ADDENDUM NO. 5

DATE: March 18, 2020

PROJECT: Hammond High School Renovation and Addition
Columbia, Maryland
Architect Project No. 18011

1 FIRST FLOOR PLAN - POWER - AREA G
E3.06 SCALE: 1/8" = 1'-0"

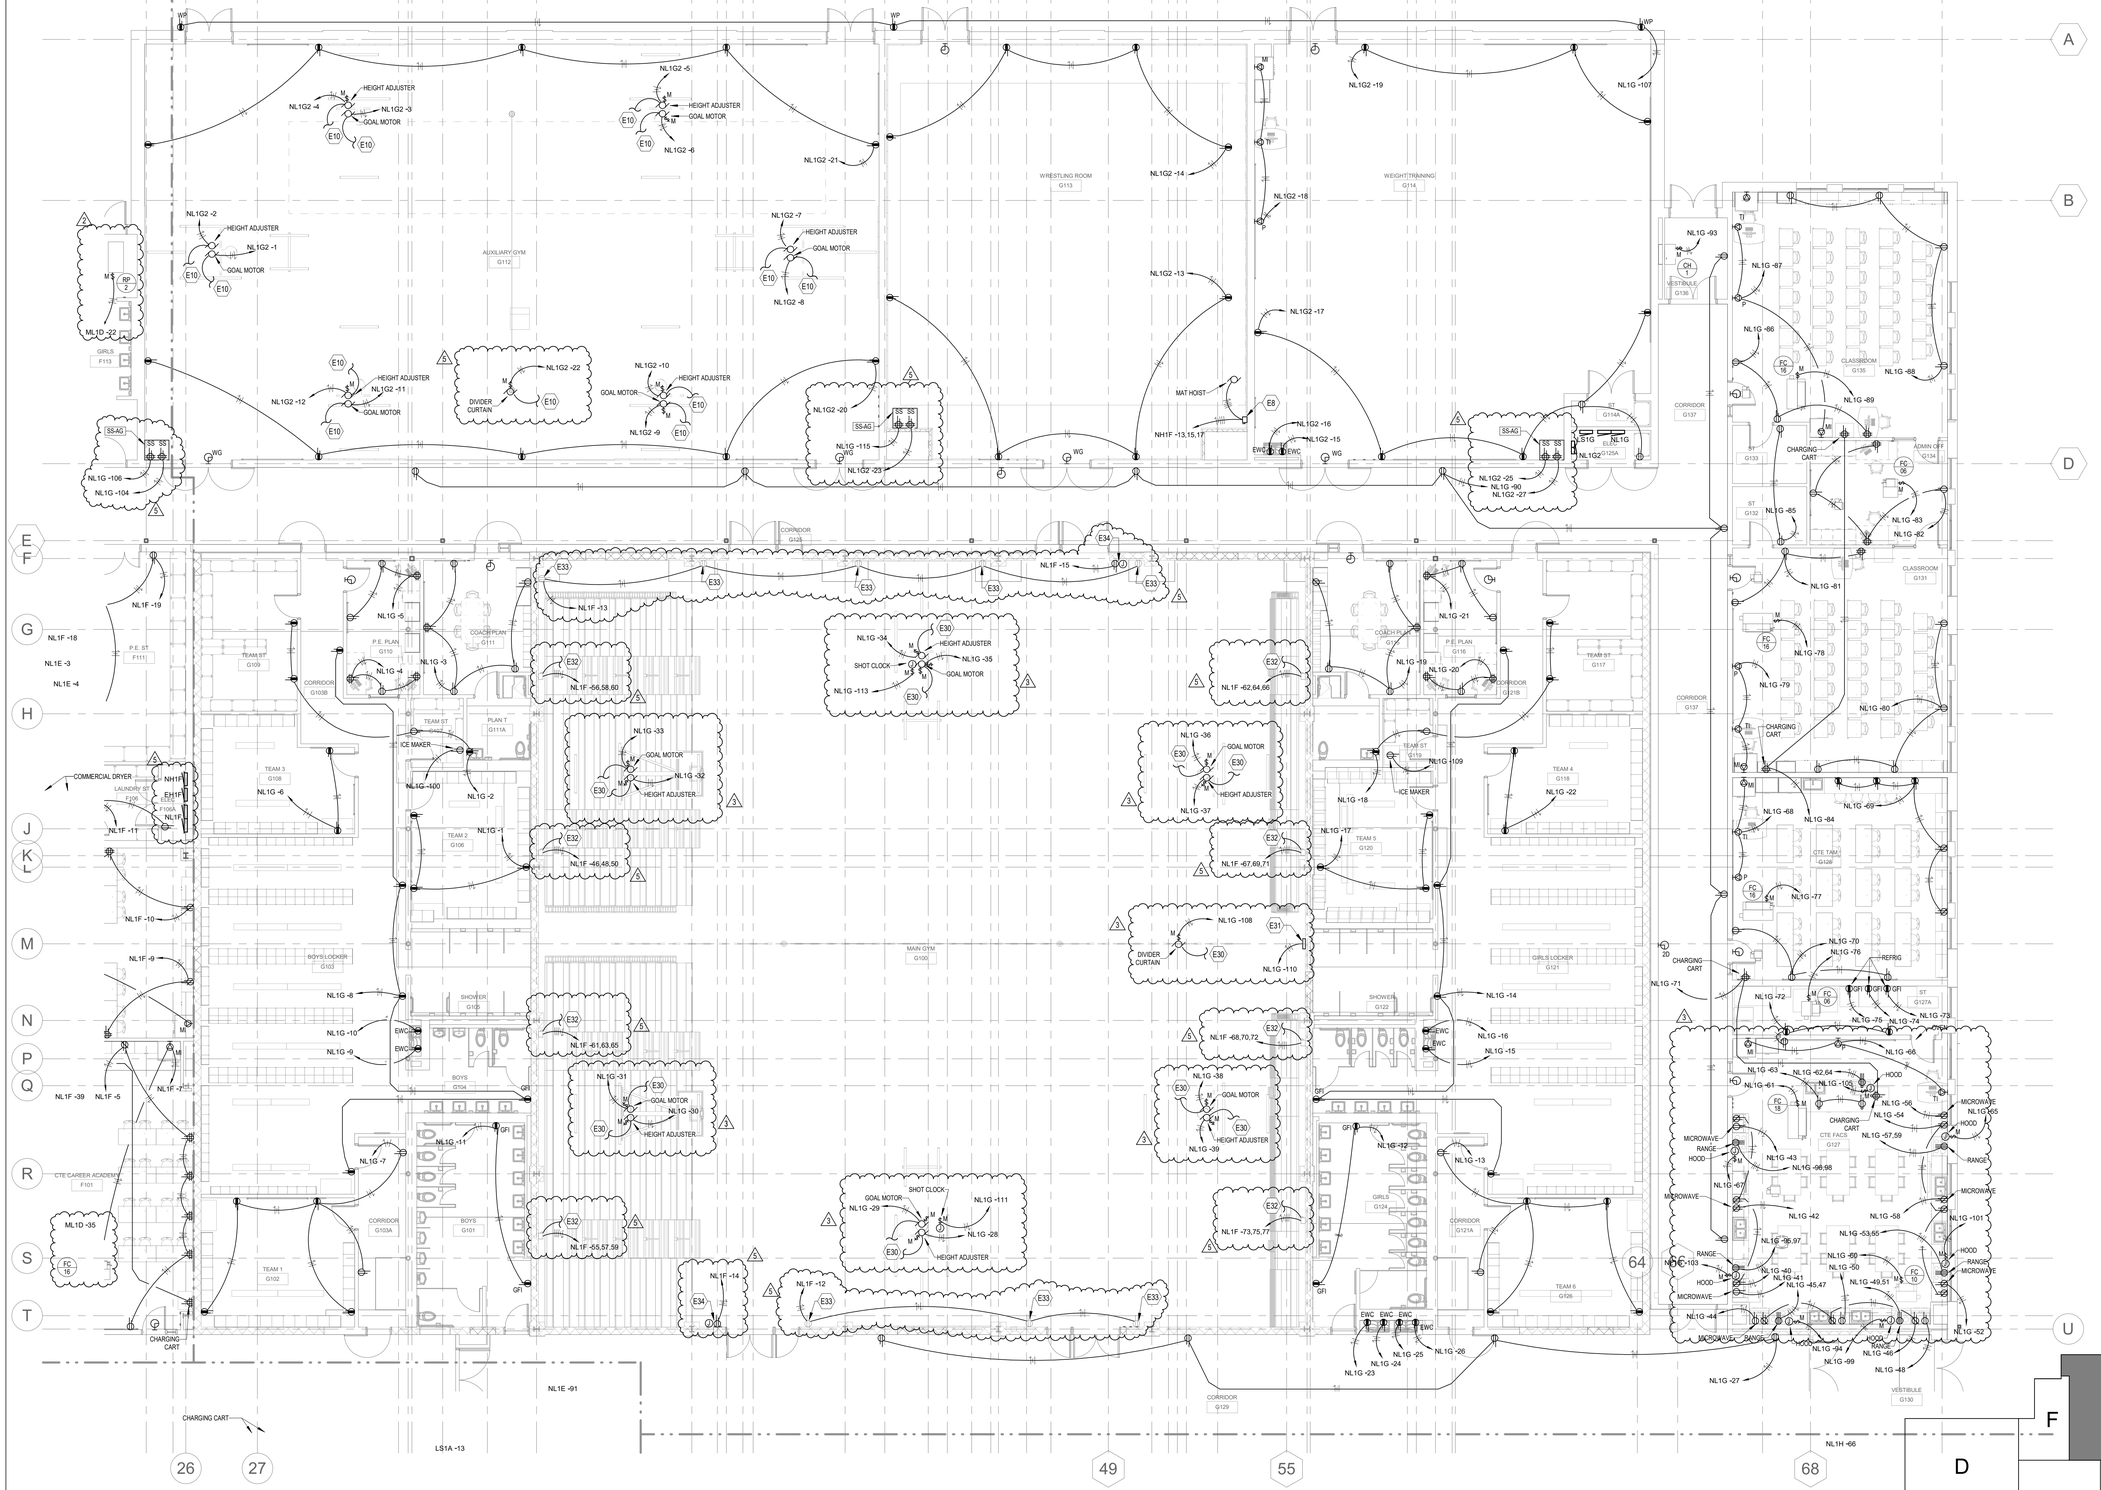
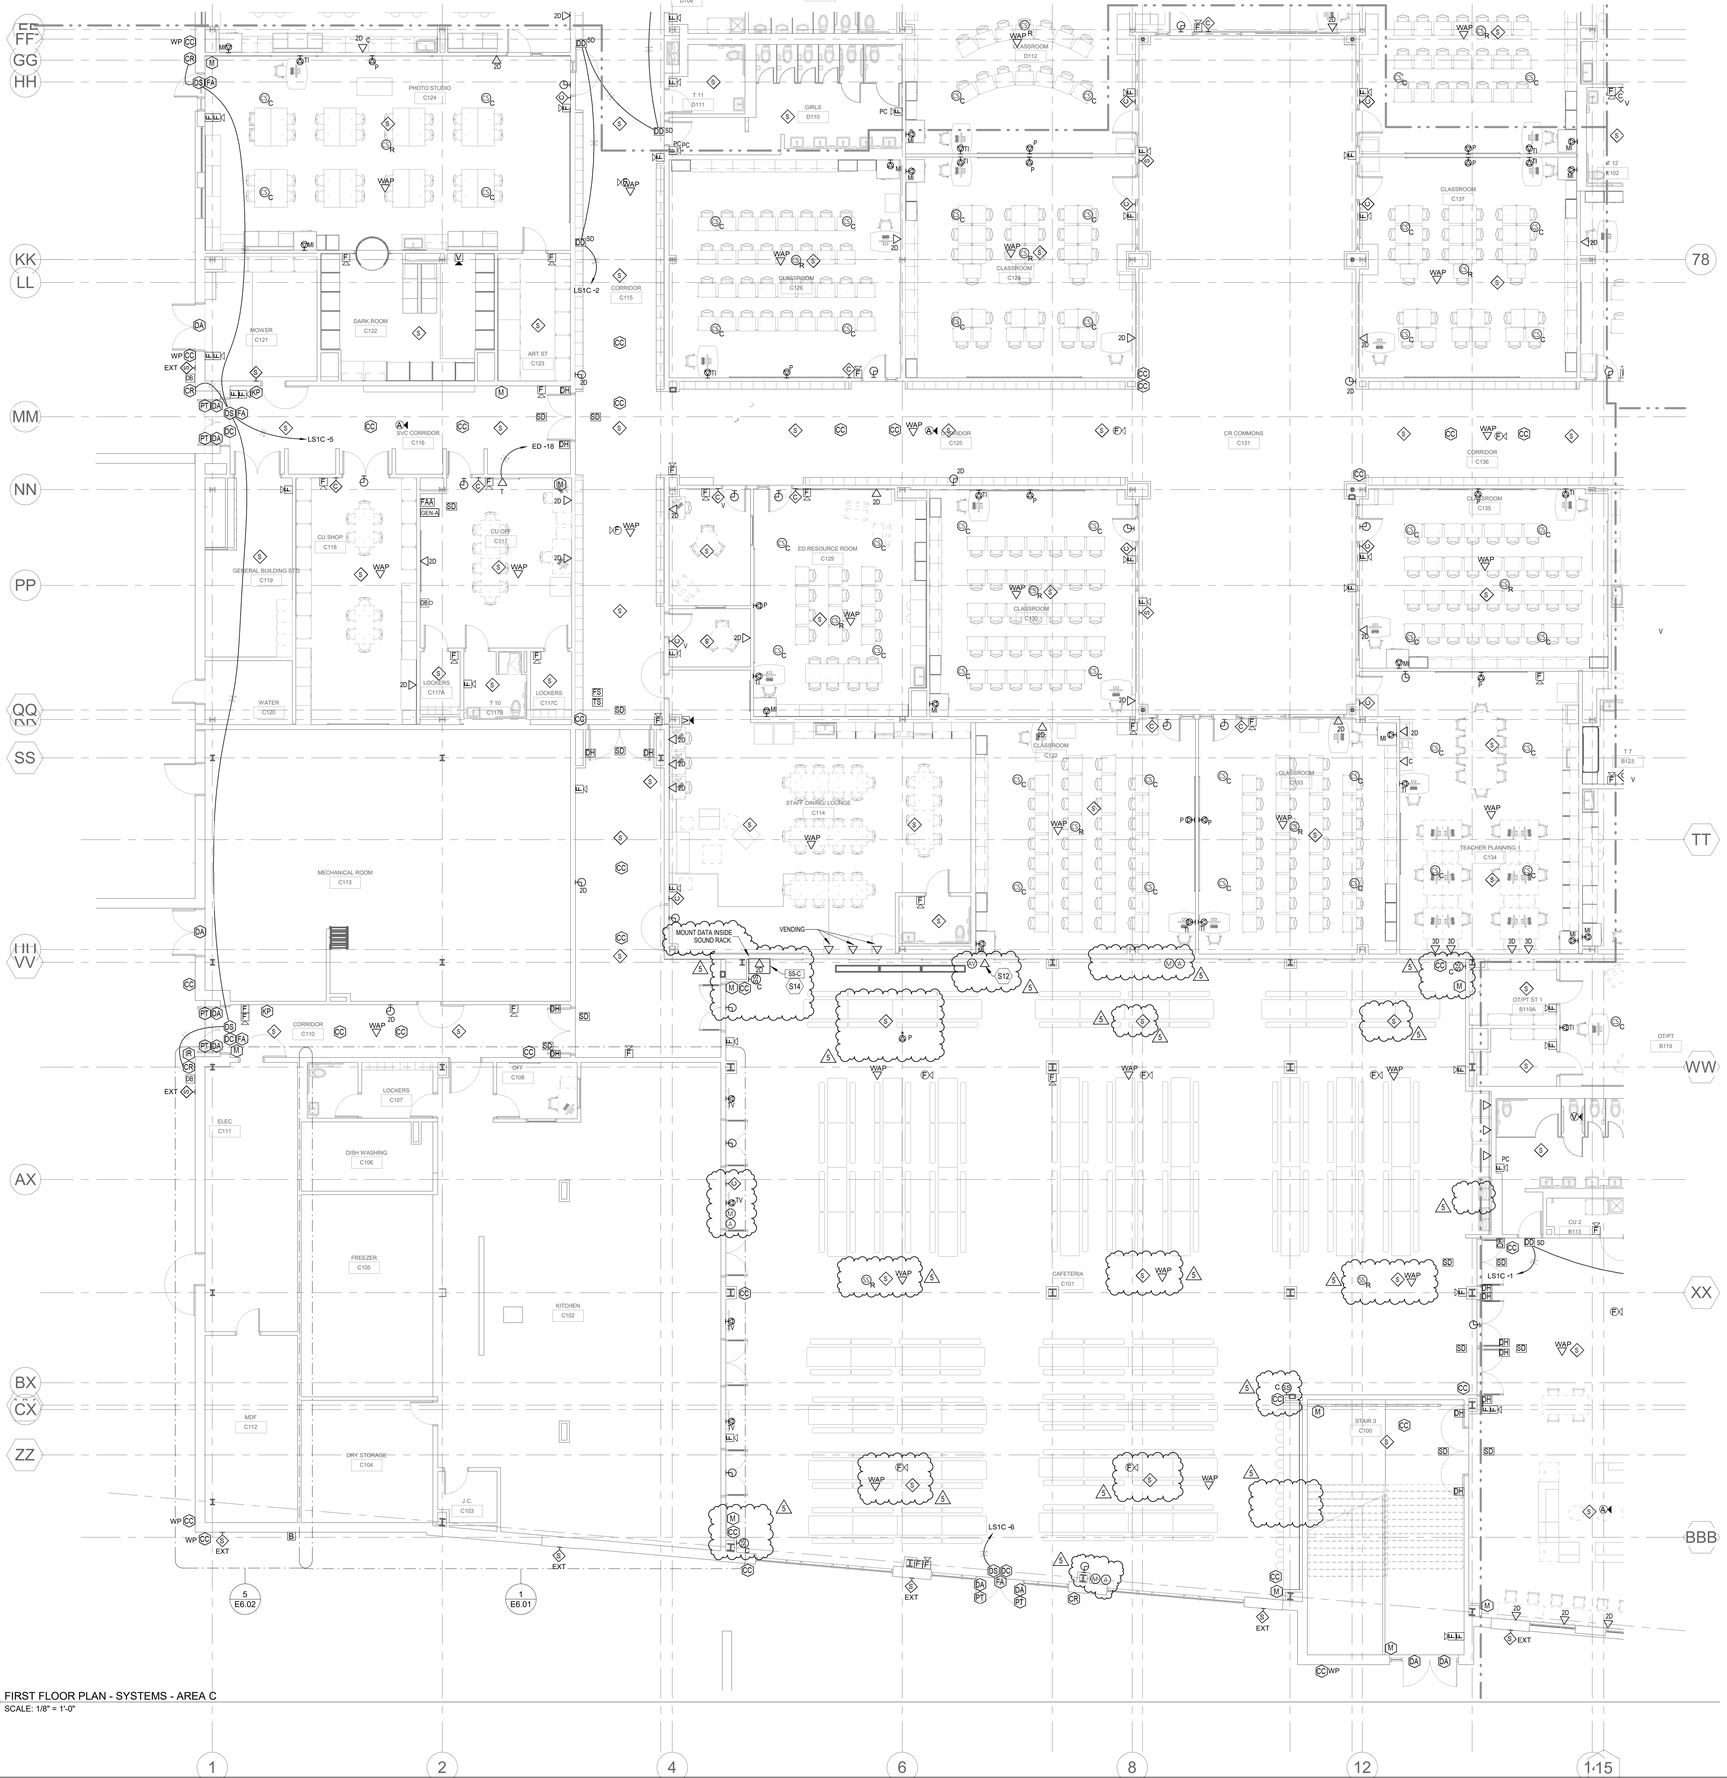
72C. Section 116623, paragraph 2.3.A. and 2.3.B. do not specify electric height adjusters but drawing E3.06 indicates a power supply for height adjusters at each basketball hoop. Are electric height adjusters required for any of the basketball hoops in each gym?

72E. Section 116623, paragraph 2.7. specifies a divider curtain but a power supply is only shown in the auxiliary gym on drawing E3.06 and drawing A9.06 only shows a divider curtain in the main gym. Will a divider curtain be required in each gym?

- ❑ Sheet E3.06 – First Floor Plan – Area G – Power
  - **REPLACE SHEET** – Changes to Main Gym G100, Aux Gym G112, Weight Room, and Wrestling, see revision clouds.

2 FIRST FLOOR PLAN - SYSTEMS - AREA F
E4.05 SCALE: 1/8" = 1'-0"

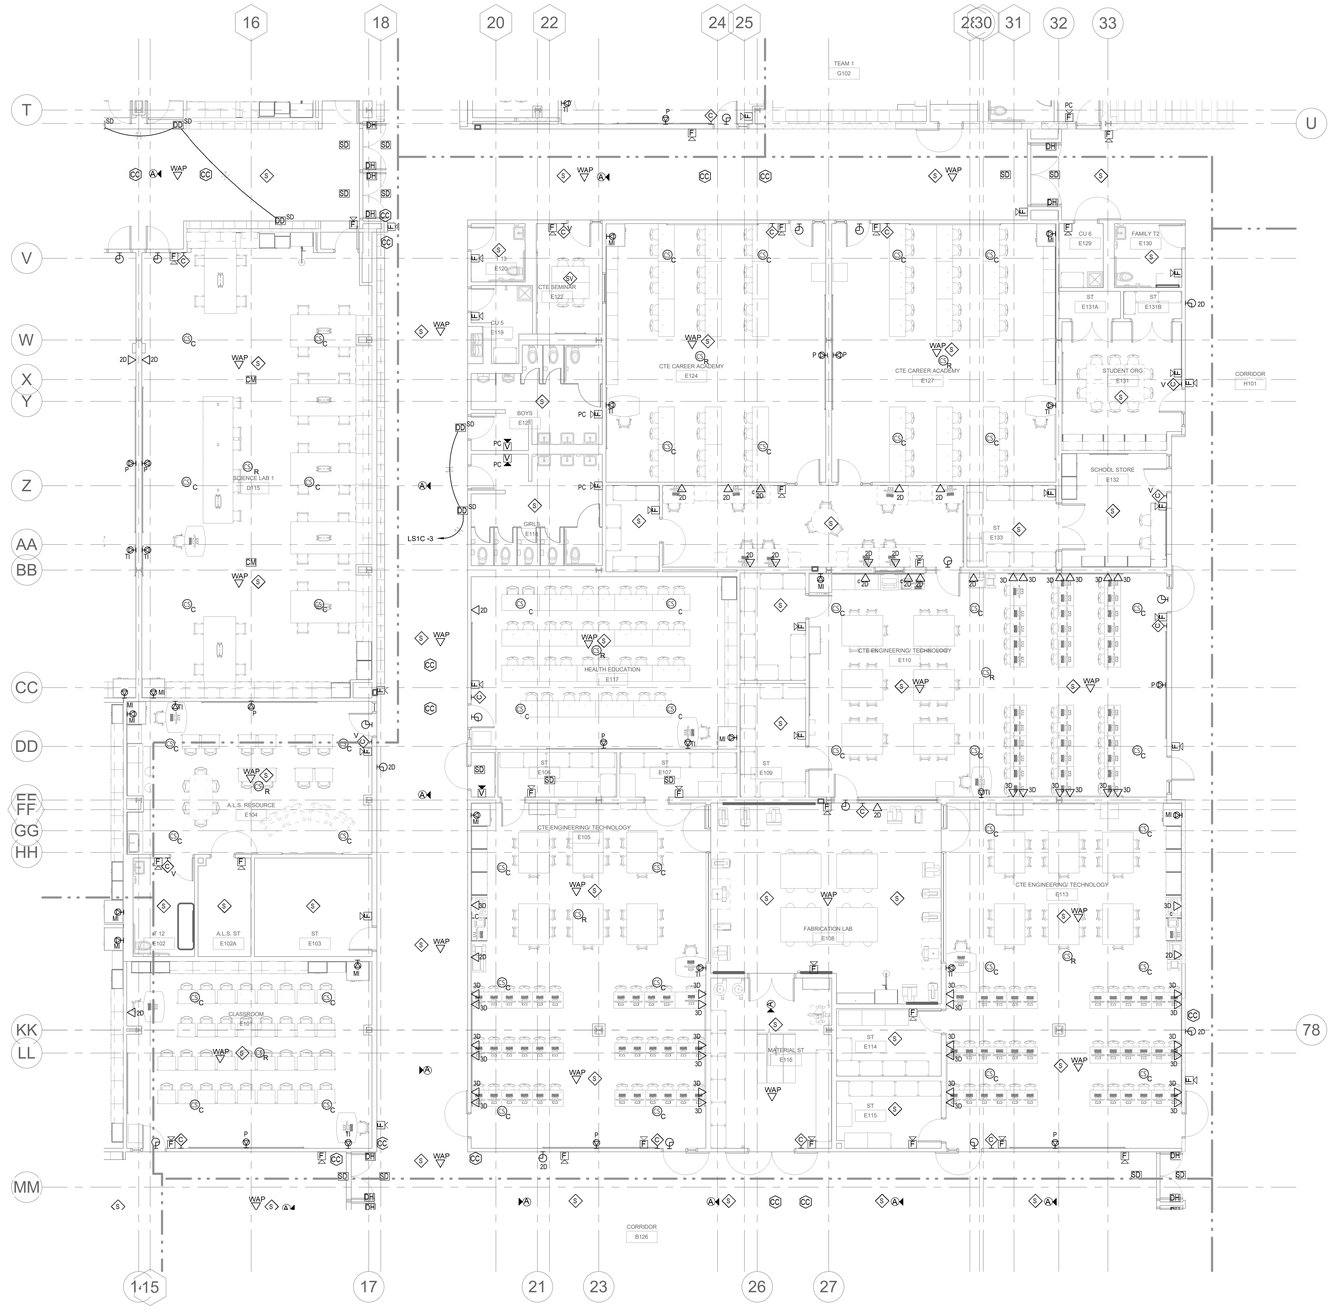
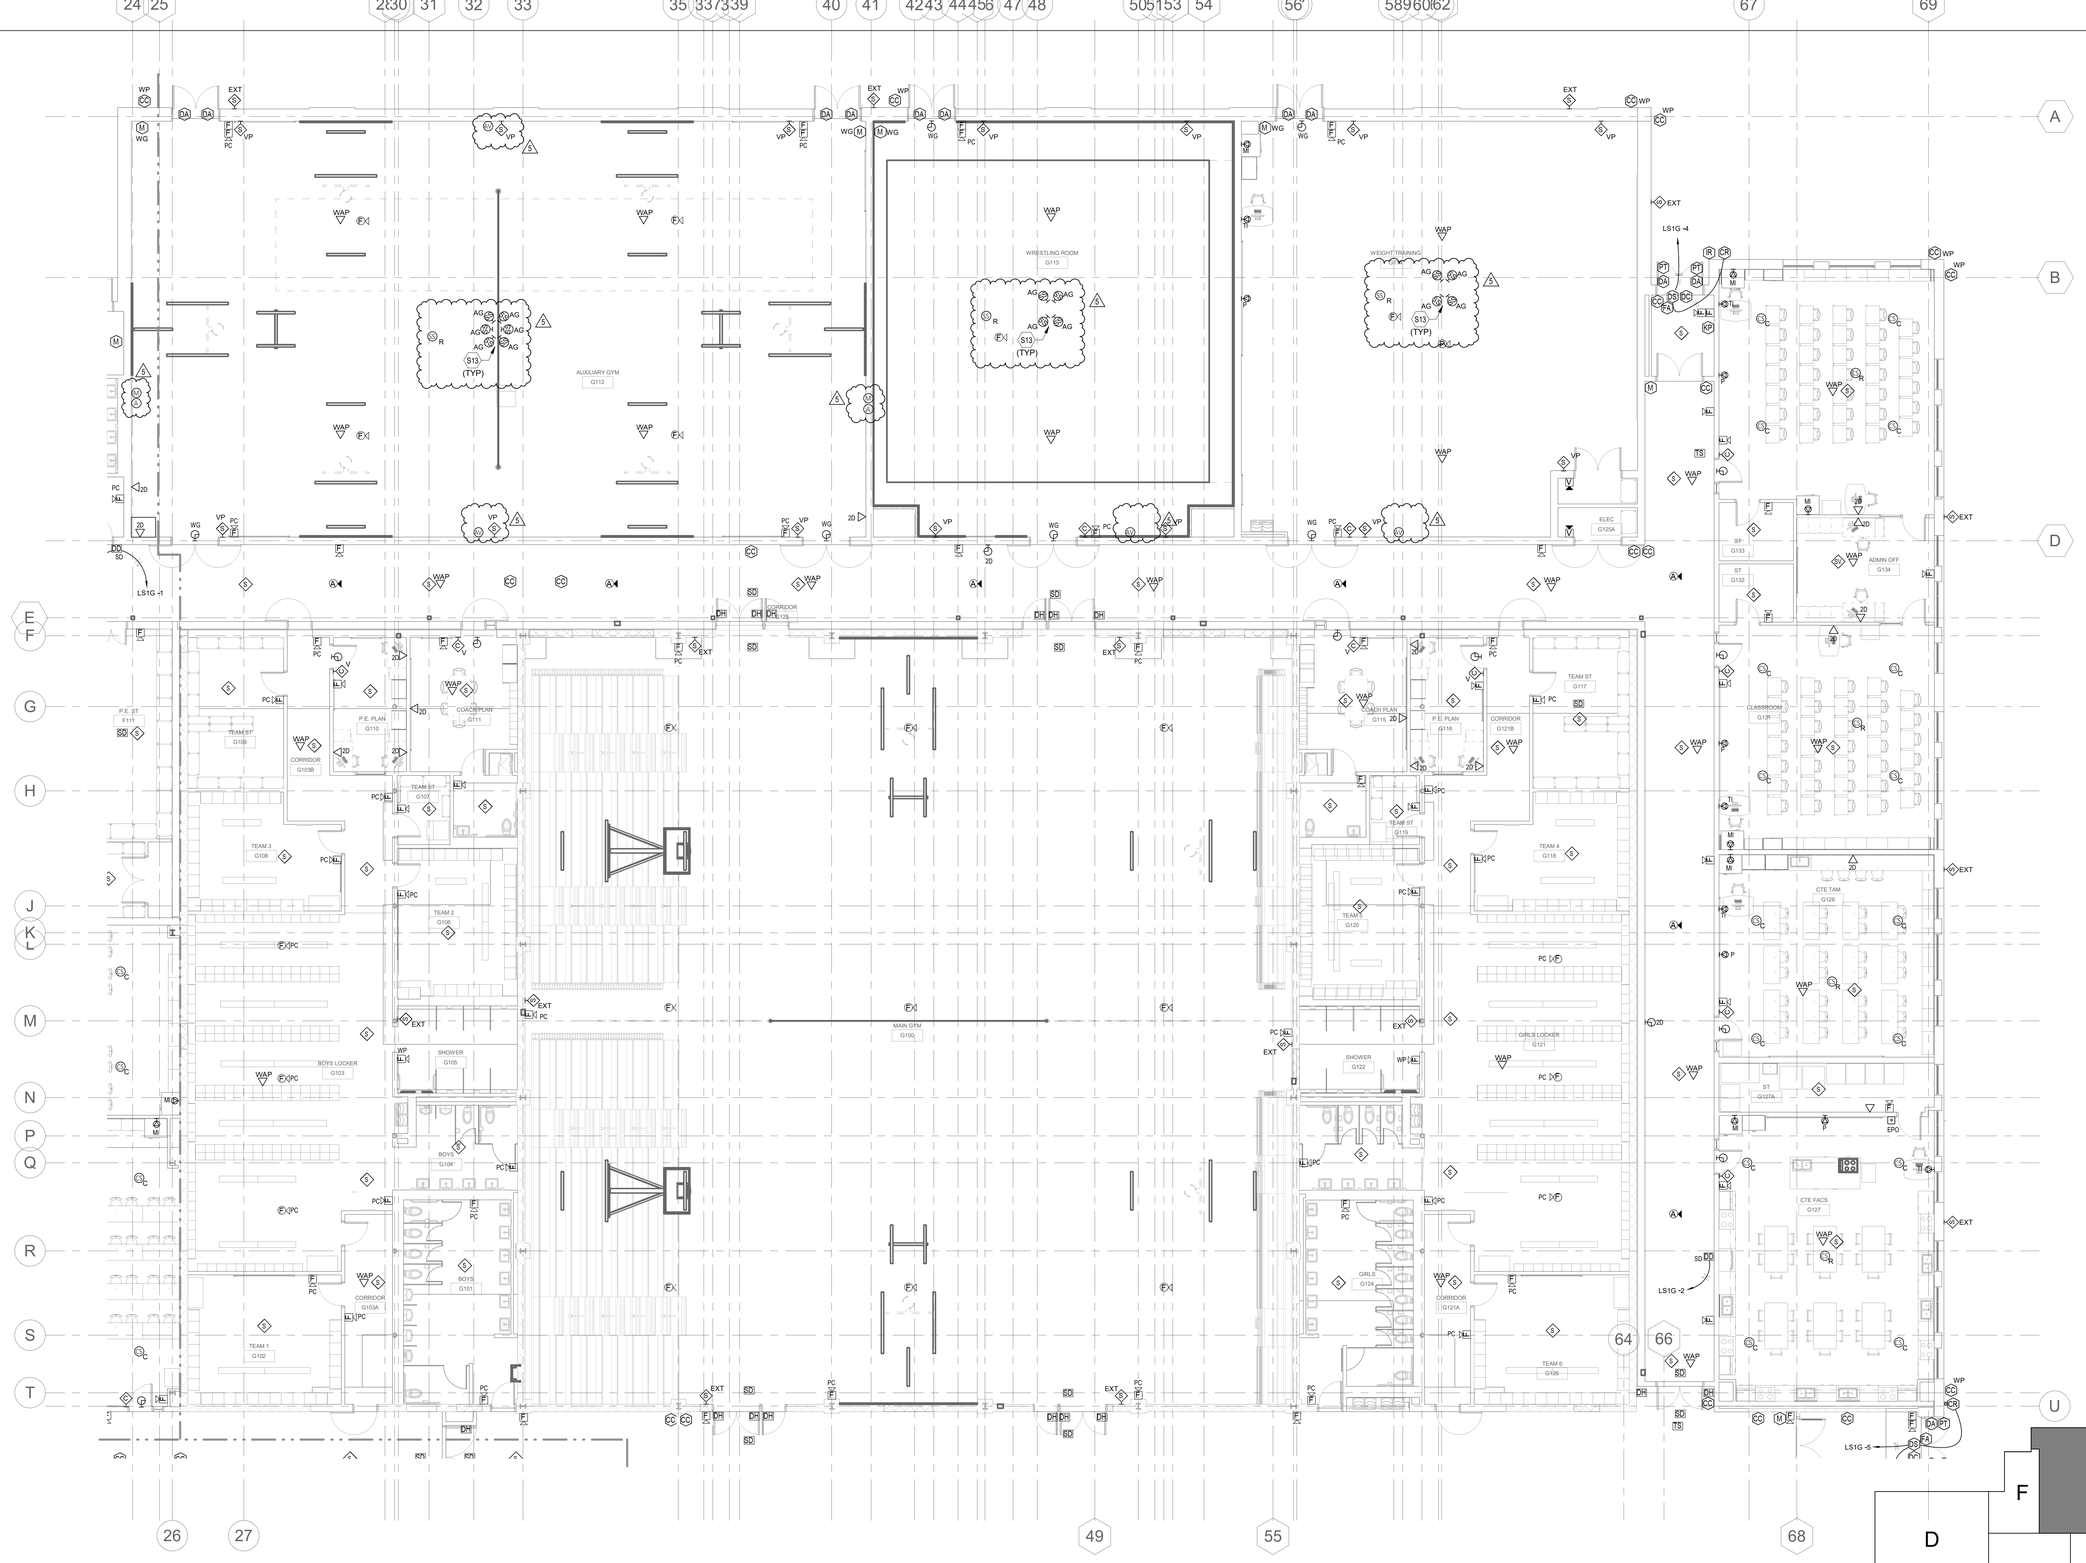
- **REPLACE SHEET** – AV changes, see revision clouds.
- ❑ Sheet E4.06 – First Floor Plan – Area G – Systems
